**CITY OF ROUND ROCK, TEXAS  
INVITATION FOR BID  
DELL DIAMOND STADIUM GATE REPAIRS**

**IFB #: 15-005**

**ADDENDUM NO. 1**

**Date: January 27, 2015**

**Area 2:** Player's gate

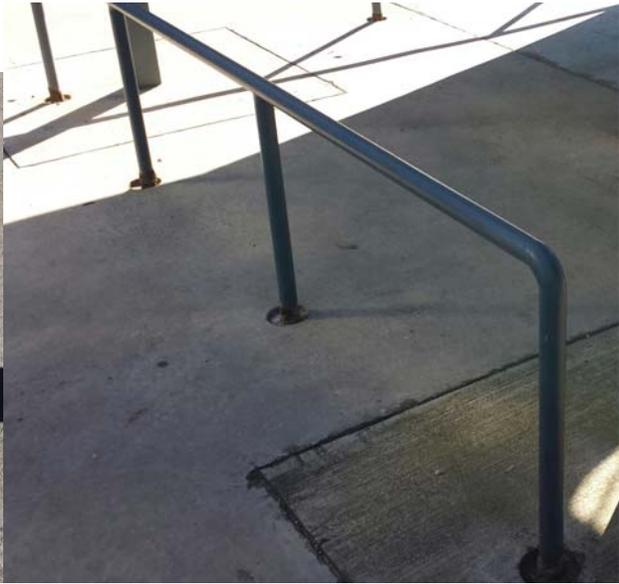
**1. Additional notes for Area 2 (Part II, Section 4.2): Player's gate.**

Stabilize player's gate with two (2) braces. Braces shall be added (welded, bolted, etc.) to each side post with a header installed over the top of the gate, connecting the braces to each side post.

**Area 4:** Center field ramp railing

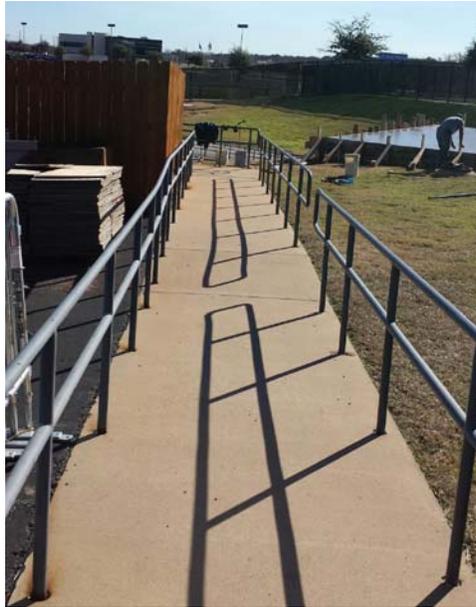
**3. Additional notes for Area 4 (Part II, Section 4.4): Center field ramp railing.**

Metal eyelets shall be installed (welded, bolted, etc.) on the hand rails between each open space, so that chains can be fastened to close off the open areas as needed. Round Rock Express will supply chains.

**Area 8:** Employee gate at back dock

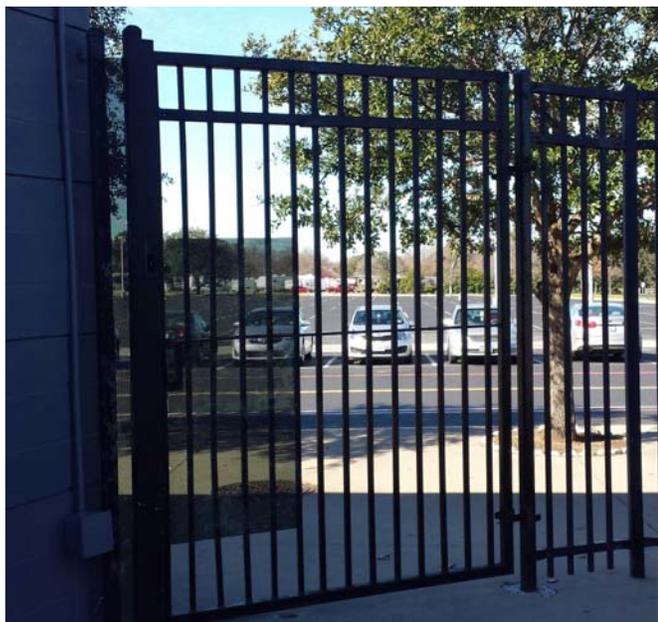
**7. Additional notes for Area 8 (Part II, Section 4.8): Employee gate at back dock.**

The current latch will need to be replaced to allow for chain and pad lock use.

**Area 9: Rocking chair seating area hand rails**

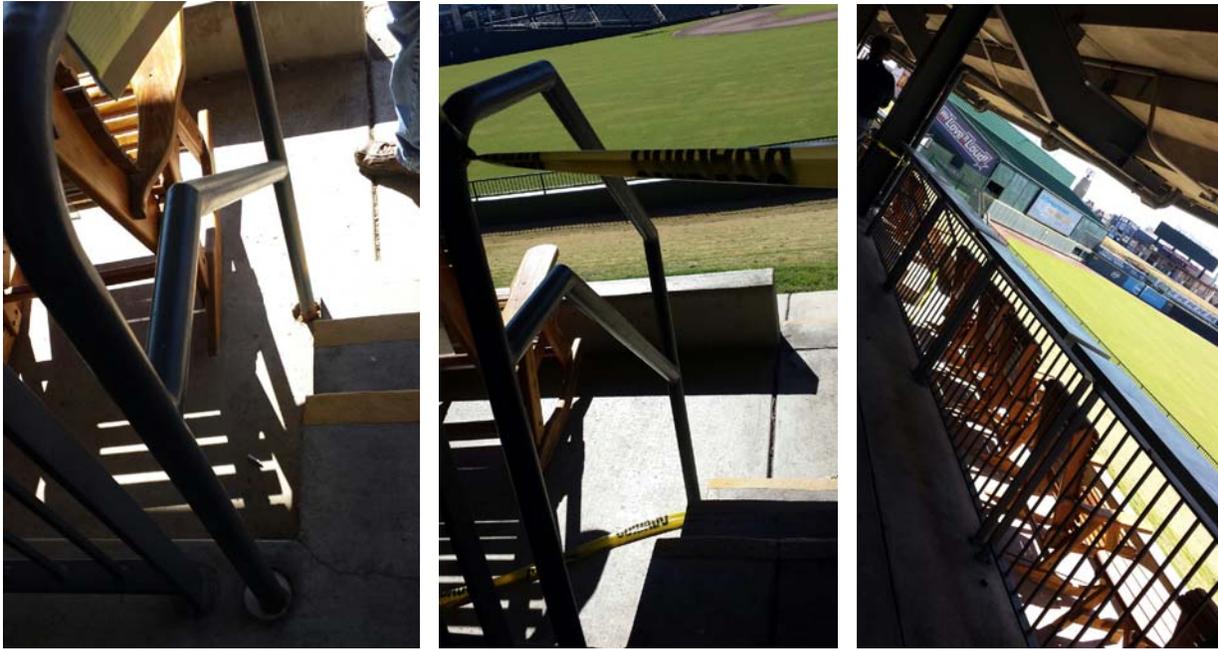
**8. Area 9 Added: Rocking Chair Seating Area hand rails.**

There are 9 single hand rails for the steps to the seating area, which will need to be replaced, or repaired in the same manner as area 1: Staircase cane guards.
